UNITED STATES PATENT AND TRADEMARK OFFICE

10/586,941

Office Action Summary	Application No. 10/586,941	Applicant(s) STOCK, ANDREW	
	Examiner MATTHEW T. MARTIN	Art Unit 1795

DETAILED ACTION

FIG. 4

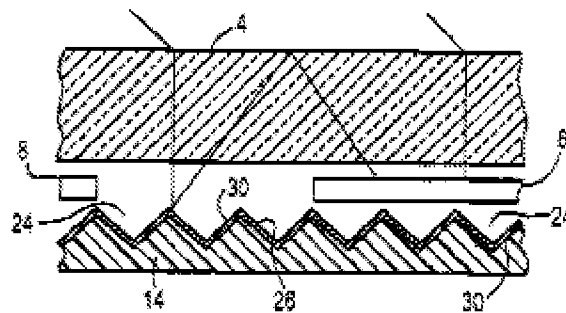
An array of solar cells (8). Gonsiorawski shows each cell having a front and a back (see fig. 4), and the front, light receiving surface of each individual cell is capable of converting at least a portion of solar light incident into electrical energy (see column 1, lines 5-15). Furthermore, Gonsiorawski both teaches (see abstract) and shows (see fig. 4) spacings between the individual solar cells (8; see fig. 4 and column 1, lines 25-35);

The internal reflector facet (26) is interpreted by the examiner as an element comprising a visually distinguishable feature, because the present specification defines one embodiment of the element as a reflector (see paragraph 14). Additionally, Gonsiorawski teaches that using an encapsulant to protect the solar cells. The present application also identifies an encapsulant as one of the potential embodiments for the element (see paragraphs 15 and 16), so the claims of the present application are also interpreted such that an encapsulant is considered a visually distinguishing feature. Furthermore, neither the reflector nor the encapsulant taught by Gonsiorawski prevent solar light incident on the panel front from being incident on the array.

Regarding Claim 2, Gonsiorawski teaches that all light incidents on the panel front will also be incident on the cell, because Gonsiorawski teaches that the panes front is transparent, and therefore would not obscure any light from the cell (see fig. 4 and abstract).

Regarding Claims 11-14, Gonsiorawski teaches an encapsulant, a visually distinguishable element taught by applicant, in the space between the front and back cover (see fig. 4 and column 5, lines 45-50). This includes the area between individual solar cells of the array.

Regarding Claim 15, Gonsiorawski teaches a module with a panel front (4; see fig. 4). Additionally, it is examiner's position that the panel front is visually

Regarding Claim 26, Gonsiorawski teaches locating a reflector (26) capable of reflecting solar light (see fig. 4) towards solar cells in the array (see fig. 4).

Regarding Claims 8 and 9, Gonsiorawski teaches a solar cell array as discussed above, including a reflector that is capable of reflecting light onto the cell, including the backs (see fig. 4).
